Nine Mile Point
Nuclear Surveillance Program-
A Summary

Linda Bond Downing
and
R.J. Scudato

Research Center
Piez Hall
SUNY Oswego
Oswego, NY 13126

Figure 8. New York State Department of Health for Cesium - 137, Uranium - 238 data from offshore Lake Ontario bottom sediment data for the period 1981 - 1988. Note the large change in Cesium - 137 after 1984.

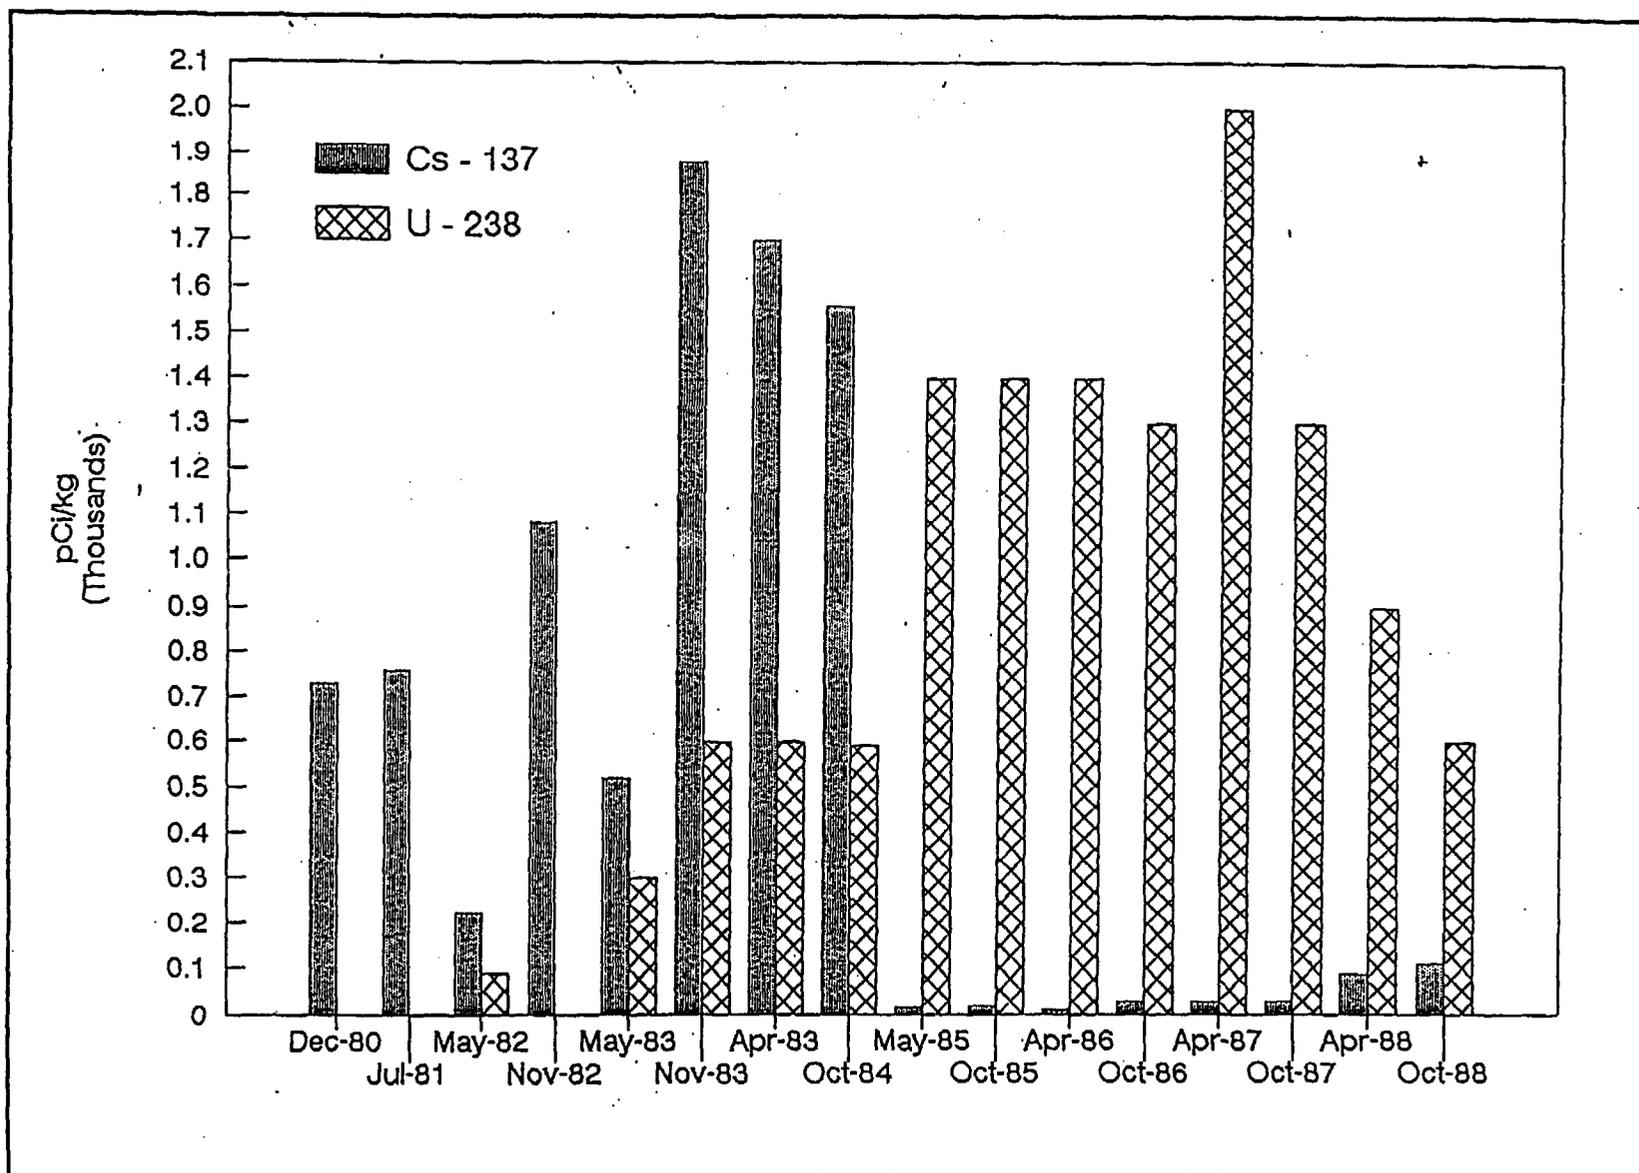
Cesium¹³⁷ in bottom sediments declined substantially in 1985. Uranium²³⁸ more than doubled this same year and remained elevated until 1988 as illustrated in Figure 8. These changes are not accounted for in any of the reports reviewed.

- o In 1985 cesium¹³⁷ sediment activity declined substantially and uranium²³⁸ bottom sediment activity more than doubled as shown in Figure 8. With no accompanying information, there is no way to explain these variation. Thorium²³² had a minimum values of 396 and a maximum value of 690000 in table 1G. These large variations should be addressed and explained.
